Carolina Power & Light Company

SERIAL: NLS-84-500

BRUNSWICK STEAM ELECTRIC PLANT, UNIT NOS. 1 AND 2
DOCKET NOS. 50-325 & 50-324/LICENSE NOS. DPR-71 & DPR-62
DEMONSTRATION OF CONTAINMENT PURGE AND VENT VALVE OPERABILITY

FIGURE 1

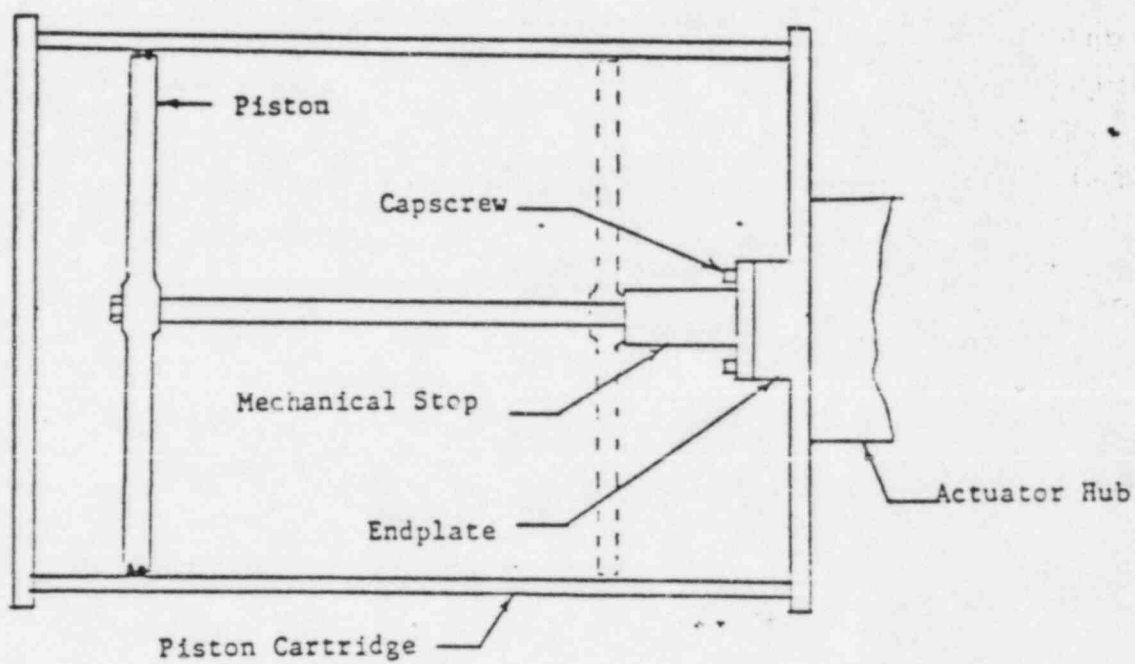
Based on analysis performed by POSI-SEAL International, Inc. (provided by letter dated February 29, 1984), CP&L demonstrated operability of the 4 and 8-inch containment purge and vent valves with no physical restriction on the degree of valve opening. The analysis also determined that the 18, 20, and 24-inch valves will properly function during a combined LOCA and seismic event with the valve opening limited to 50 degrees or less. Though the SER discussed the larger valves, it did not address the study's findings regarding the 4 and 8 inch valves. We request that the SER be revised to permit re-energizing the 4-inch valves and removal of the mechanical limits on the 8-inch valve.

Based on the above discussion, Carolina Power & Light Company requests that the SER issued September 18, 1984 be revised to permit re-energizing the 4-inch valves (CAC-V49 and CAC-V50) and to allow removal of the mechanical limit on the 8-inch valve (CAC-V4). Also, the Company commits to reflect the limitation of opening angle for the 18, 20, and 24-inch containment purge and vent valves in the next amendment to the Brunswick Updated FSAR in lieu of submitting a technical specification amendment request.
